**NEW SPENCER MIDDLE SCHOOL**

**ADDENDUM #6**

**July 20, 2022**

**THRASHER PROJECT #060-10259**

**1 ENLARGED FIRST FLOOR PLAN AREA C**  
A1.04 1/8" = 1'-0"

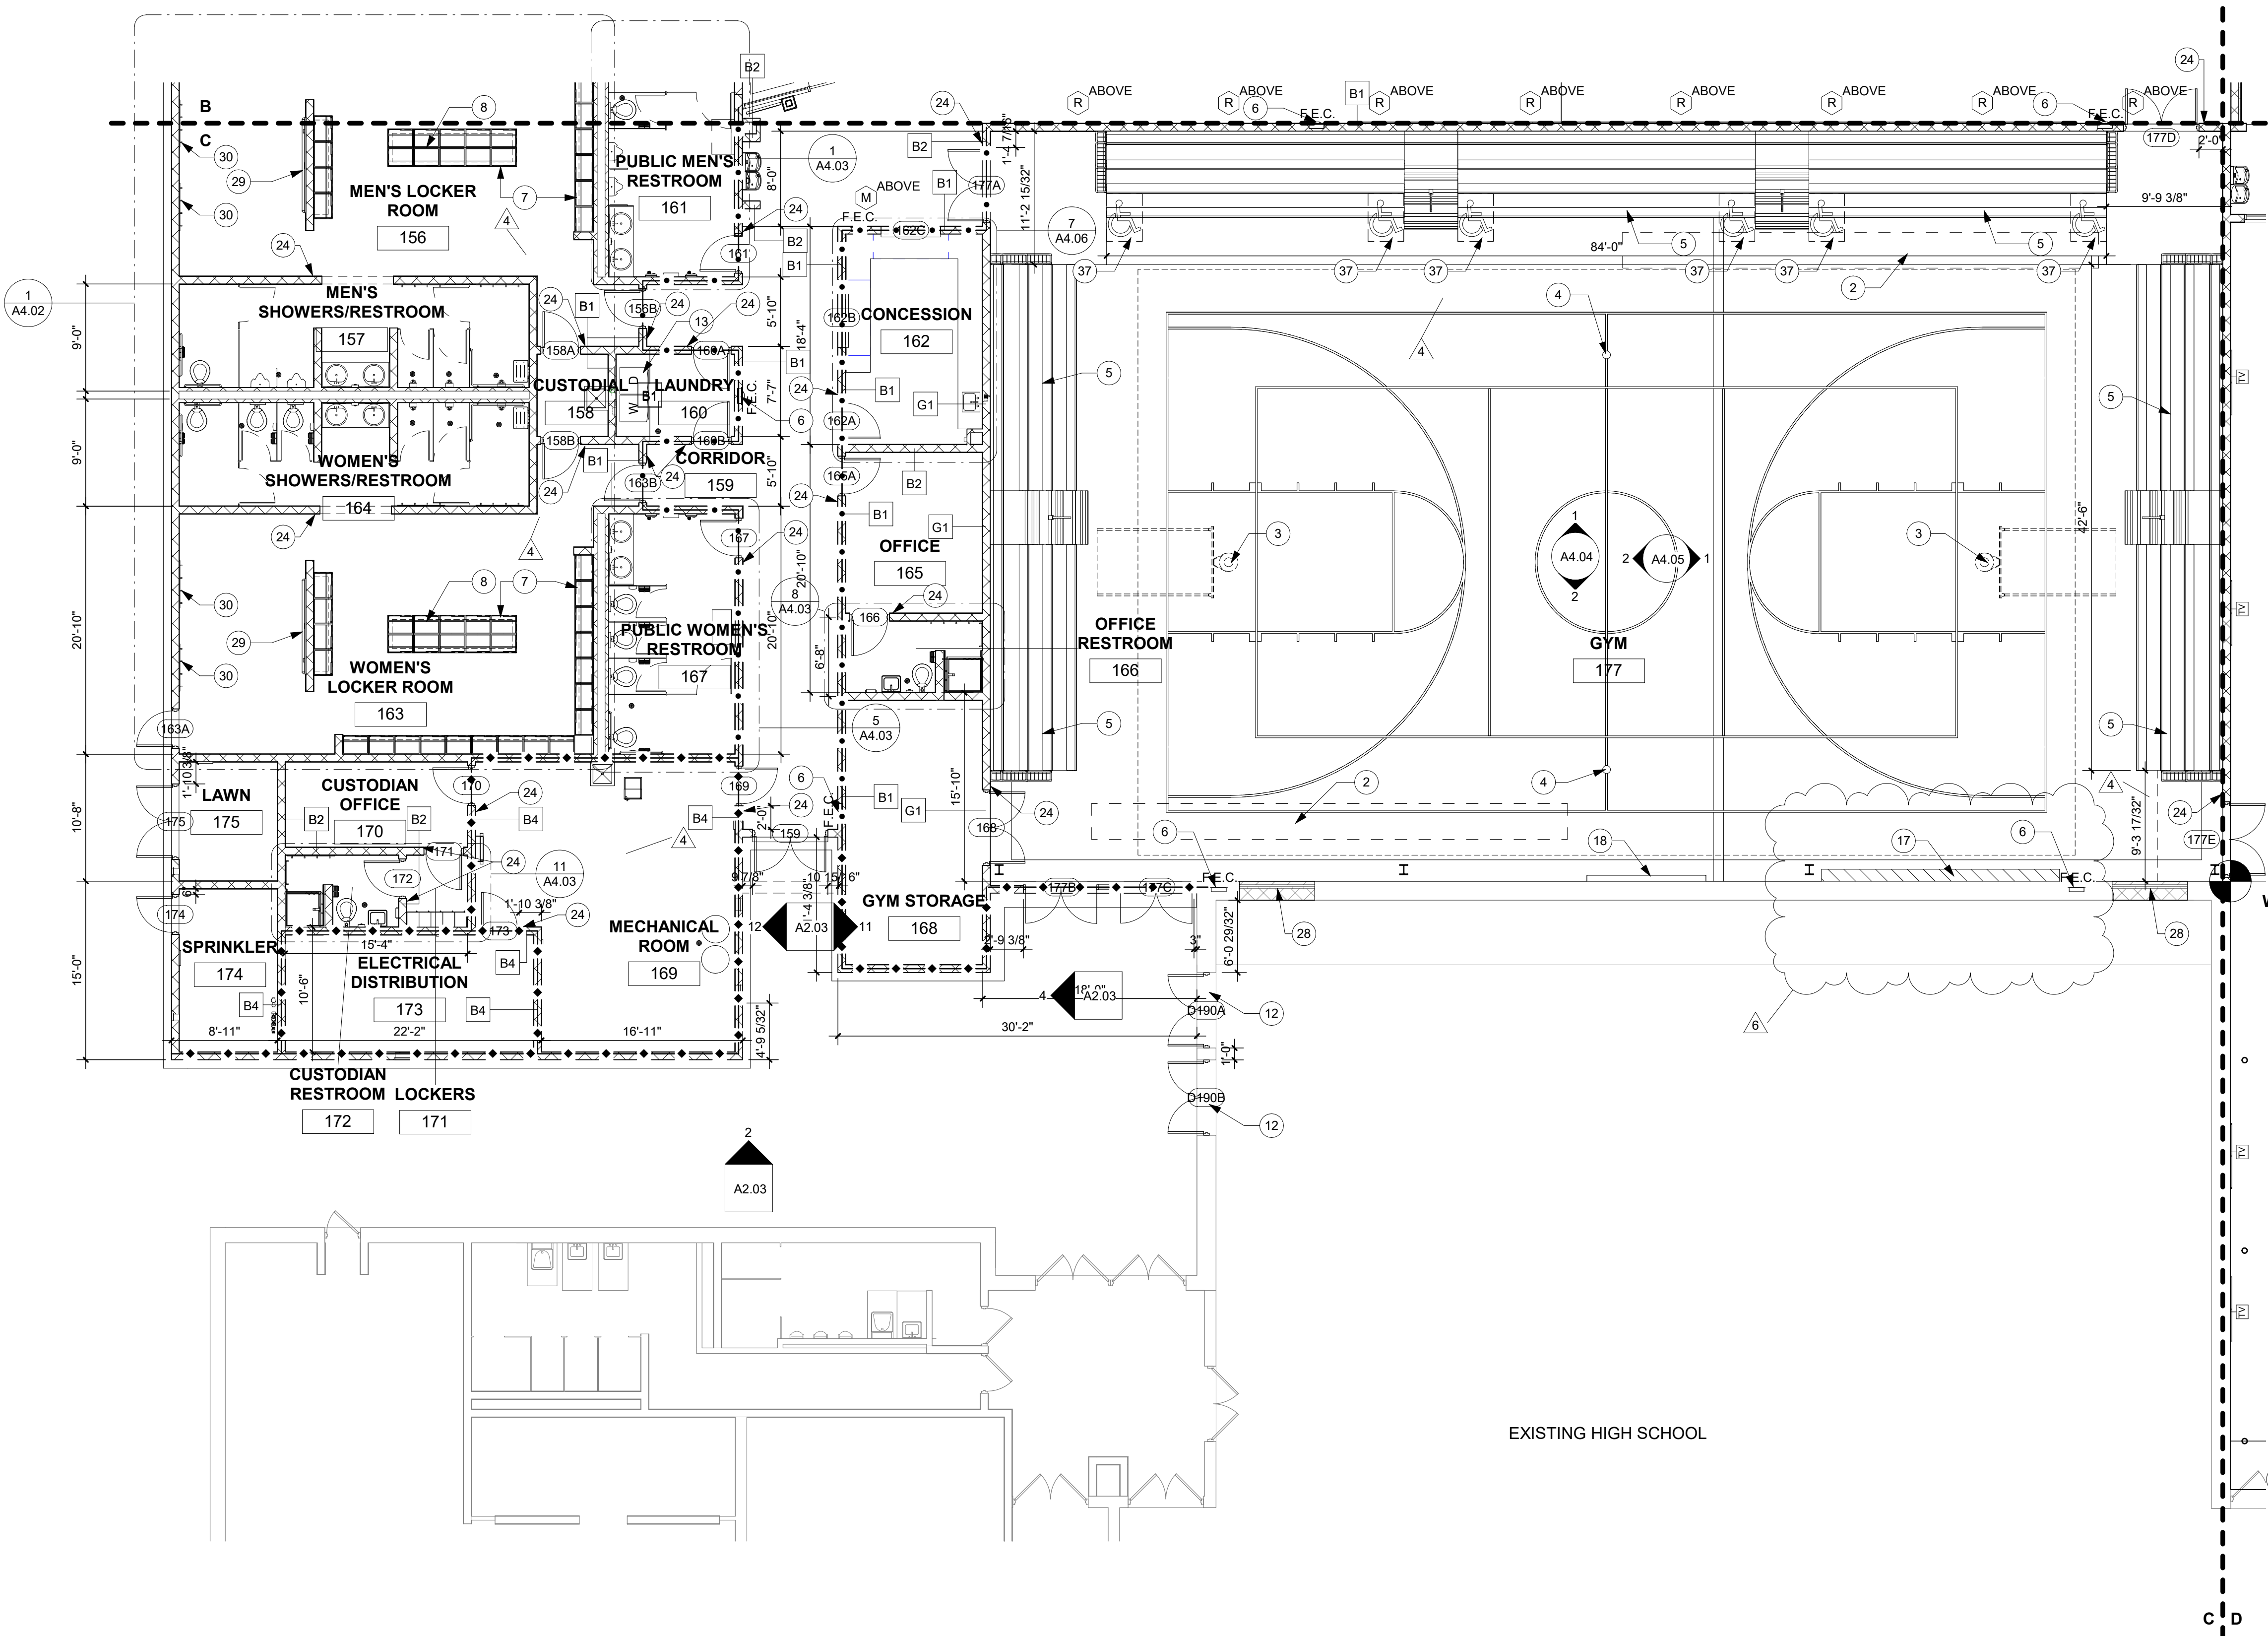
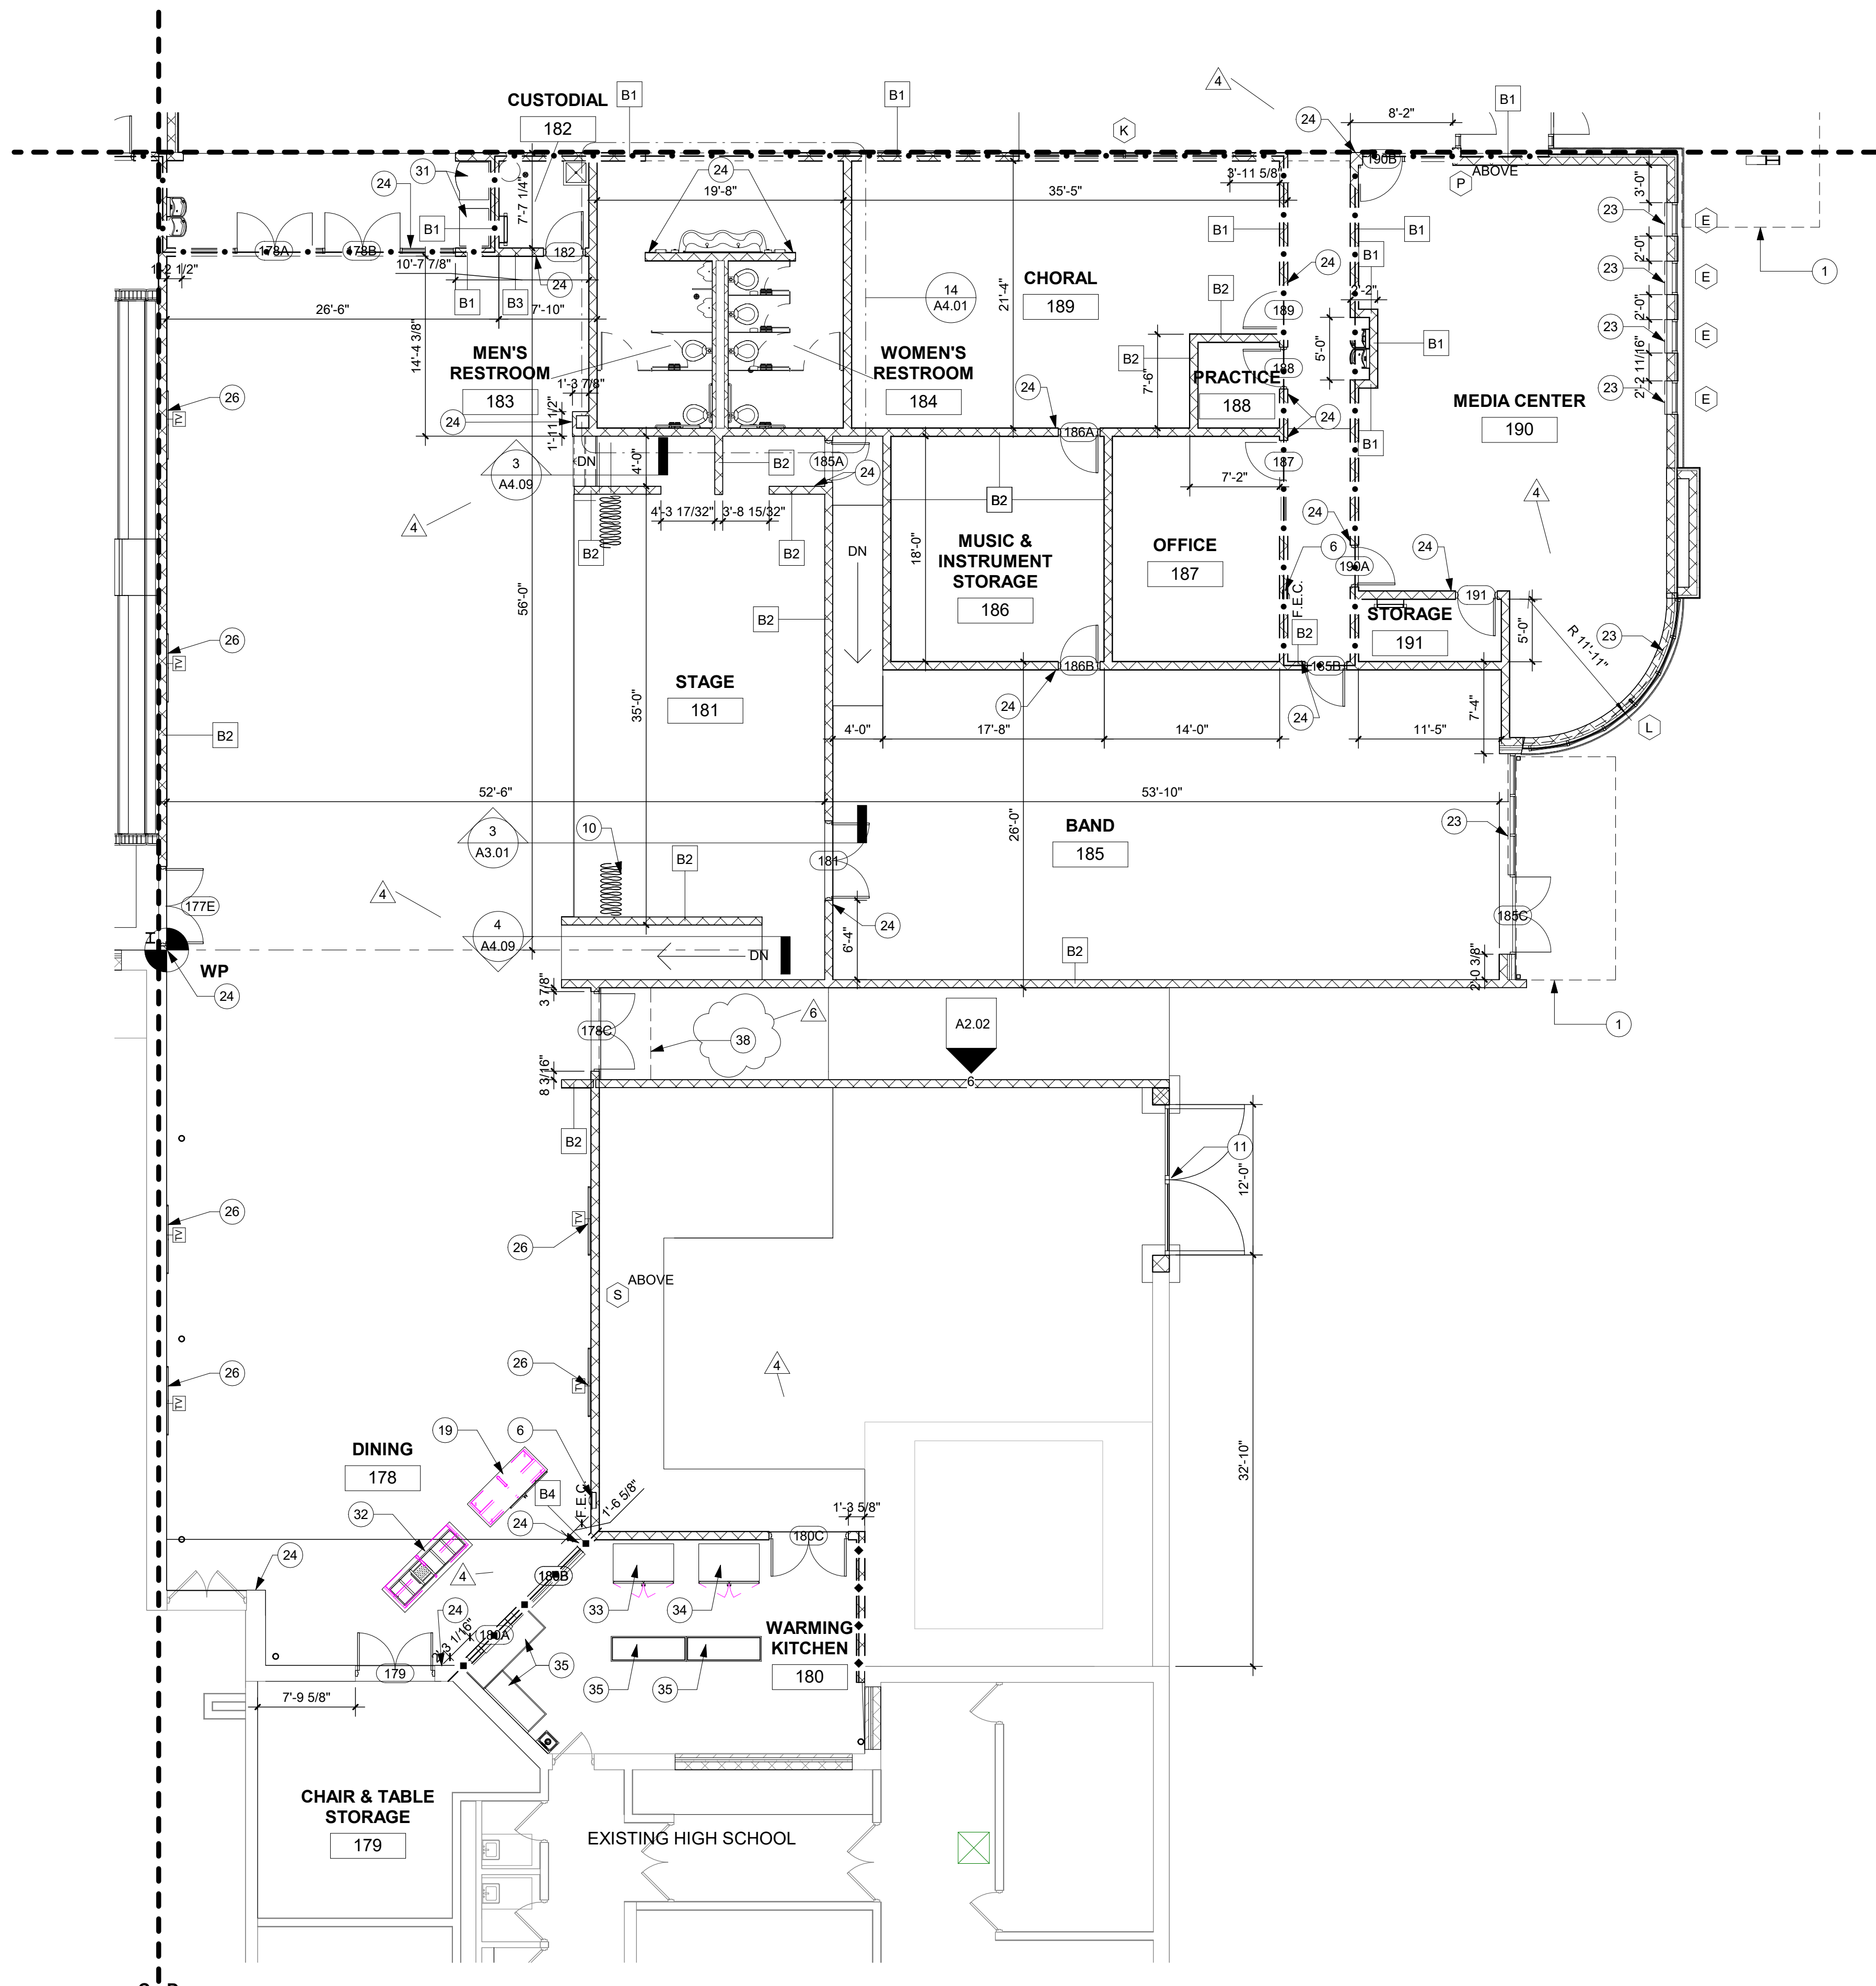
17. Addendum 4, Drawings A1.01-A1.05 revised Keynote 23 to “Line of premanufactured awnings” Keynote 23 was “Shades” and is noted at many windows and storefronts. Please clarify.

Drawing revised in this addendum.

**A3.04**

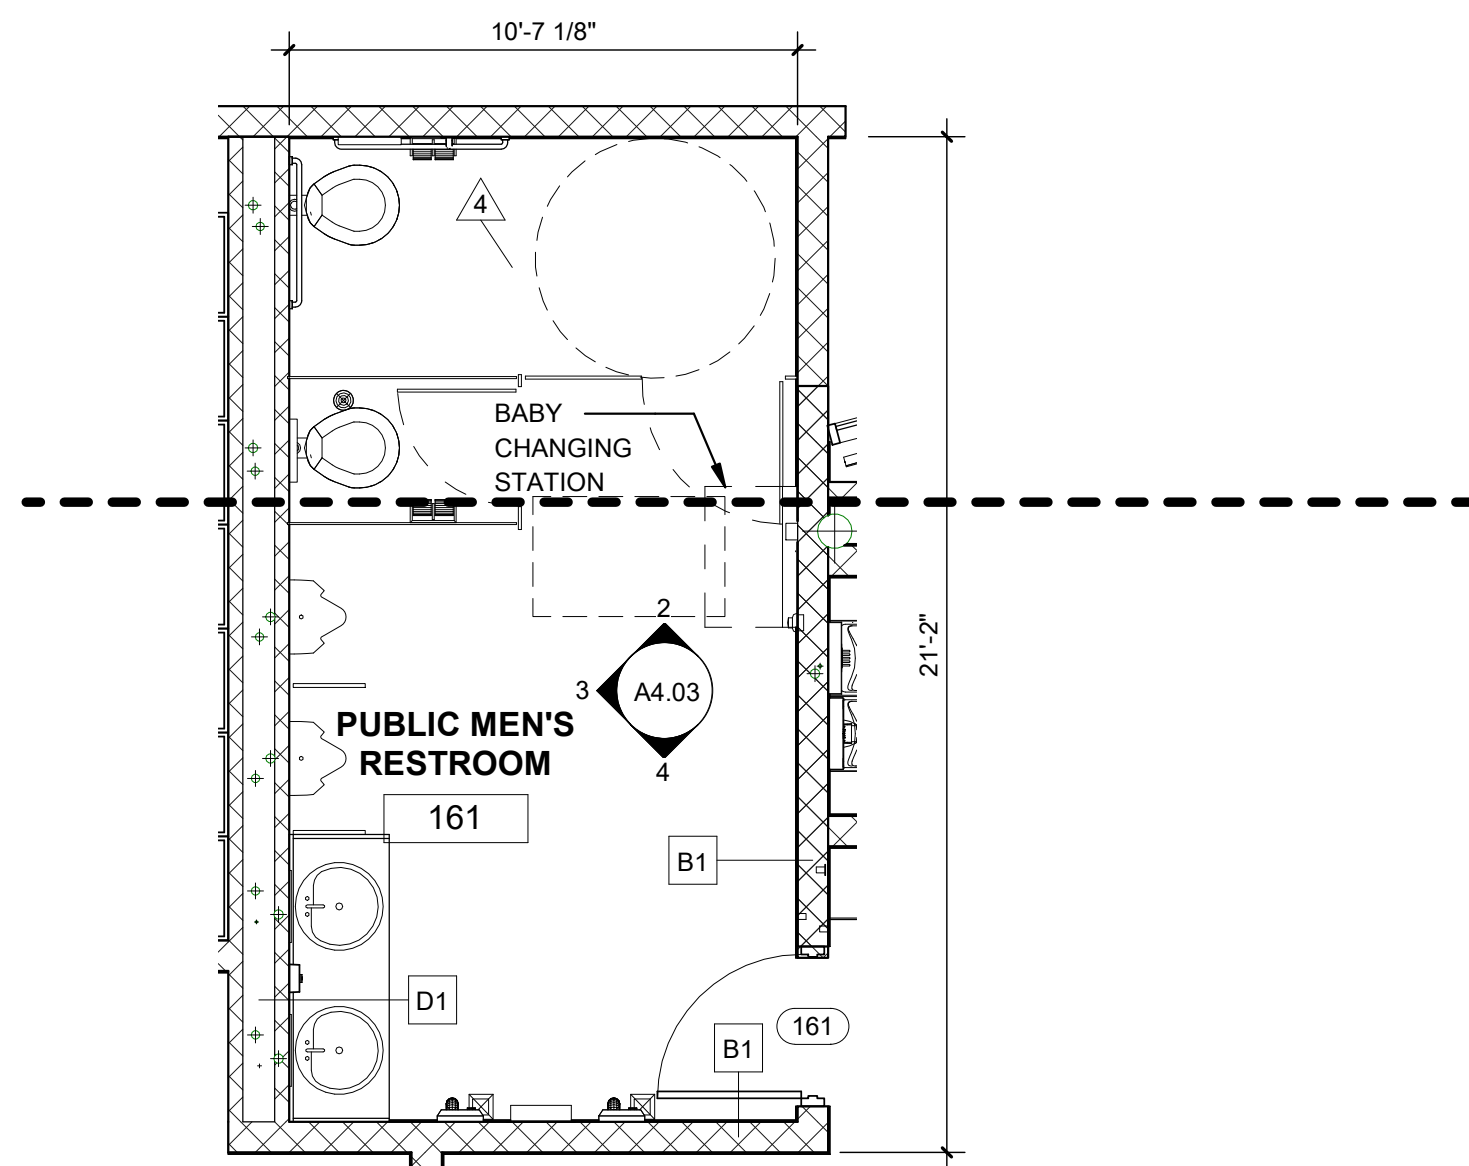
7. Requests for Specifications for Louvers at Entrance shown on Roof Plan A1.15 and Sections 3/A2.03, 2/A3.04 was answered in Addendum 3 with specifications for Louvers and Vents 089000. These specifications are not for Louvers used in the application shown on drawings. Additionally, Entrance Overhang Detail 4/A1.17 does not show Louvers. Please provide clarification and specifications for these louvers. We need a manufacturer and type to provide what is shown.

Drawing revised in this addendum.
